Donald C. Cook Nuclear Plant Unit 2
CORE OPERATING LIMITS REPORT, REVISION 2

**Donald C. Cook Nuclear Plant
Unit 2 Cycle 12**

**Core Operating Limits Report
Revision 2**

Figure 4
K(Z) - NORMALIZED $F_Q(Z)$ AS A FUNCTION OF CORE HEIGHT

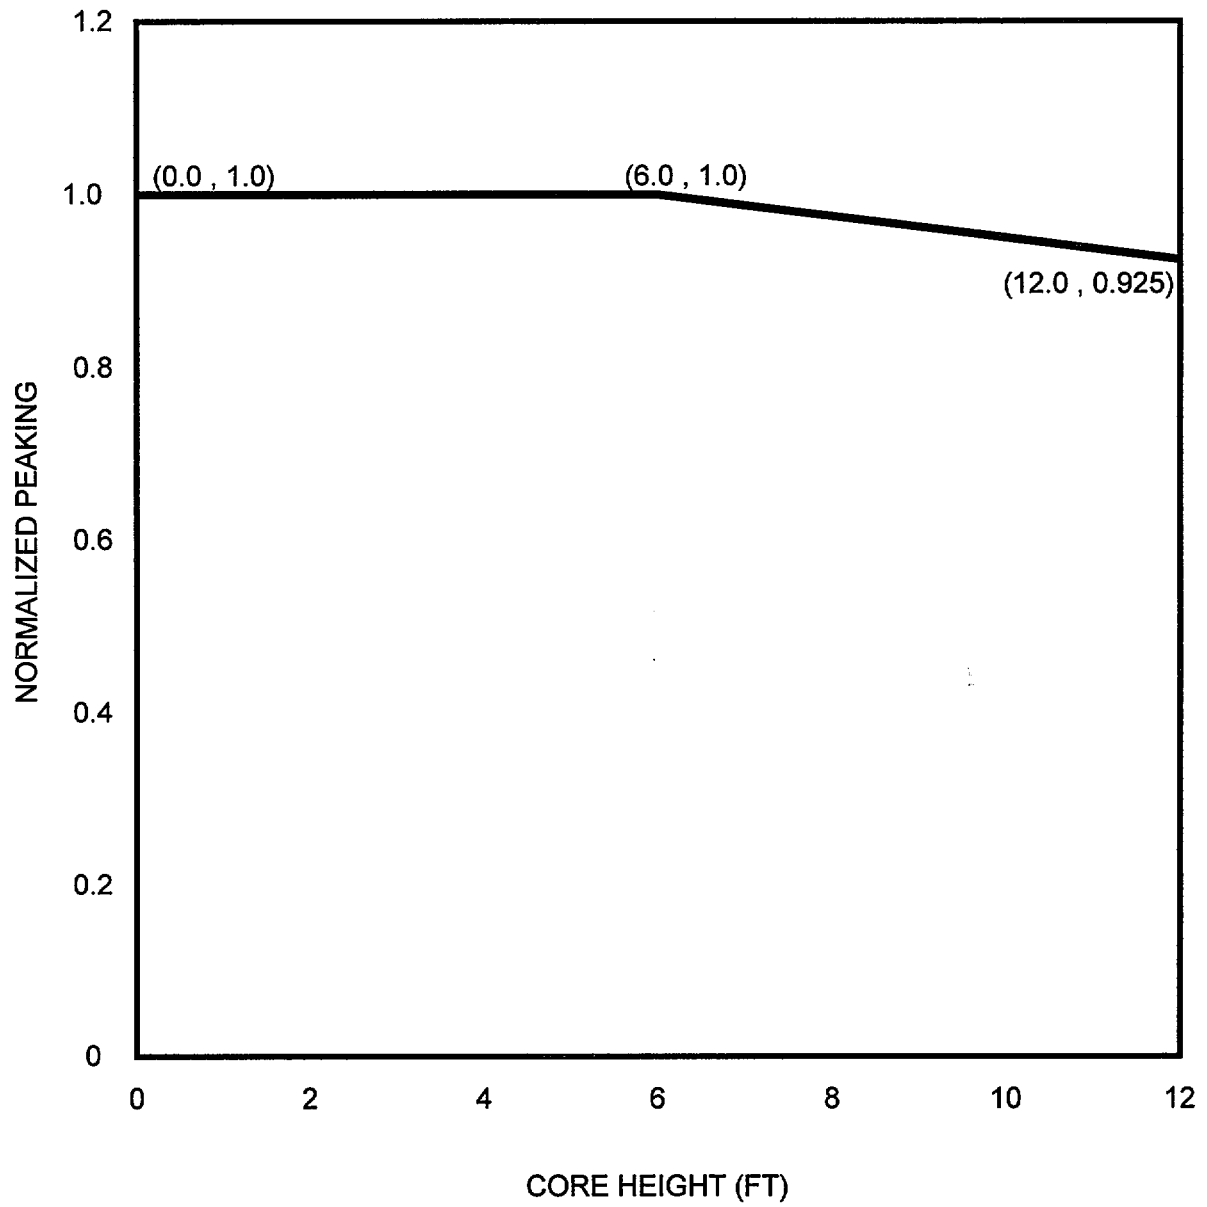
Indiana Michigan Power Company (I&M), the Licensee for Donald C. Cook Nuclear Plant Unit 2, is submitting revision 2 to the Core Operating Limits Report (COLR) for Unit 2, Cycle 12, in accordance with Technical Specification 6.9.1.9.4. The Unit 2 Cycle 12 COLR is updated to account for the change in isotopic inventory of burned assemblies due to radioactive decay during the extended shutdown. The end of life moderator temperature coefficient limits, Fp penalty multiplier, and V(Z) functions specified in the COLR are updated to reflect a recent analysis based on the current core isotopic inventory.

2.6.2 $K(Z)$ is provided in Figure 4

2.8.2 CF_Q and $K(Z)$ are provided in COLR Sections 2.6.1 and 2.6.2, respectively
